MASTER BLASTER

EL PASO COUNTY, STATE OF COLORADO
 GRADING & EROSION CONTROL PLAN

LOT 35 OF CLAREMONT BUSINESS PARK FIL. NO. 2

EL PASO COUNTY FILE NO. PPR 17-056

Figure PPS-5. Geomembrane Liner/Concrete Connection Detail

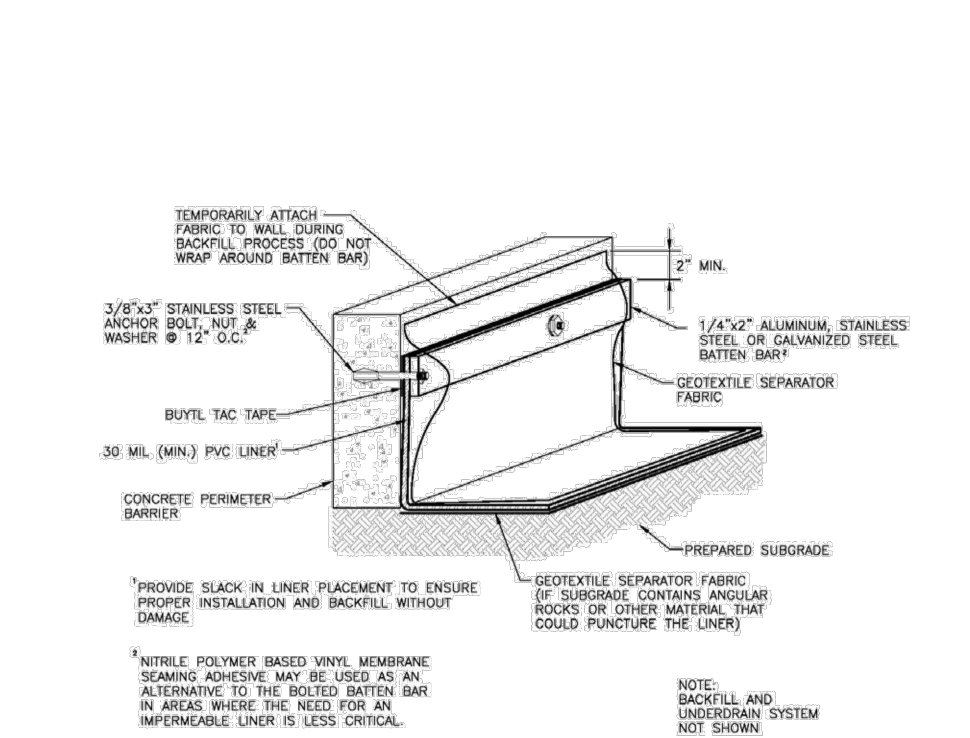
Unresolved. Per the comment in the drainage report add the bullet points as actual construction drawing notes, not just inserting page PPS-3.
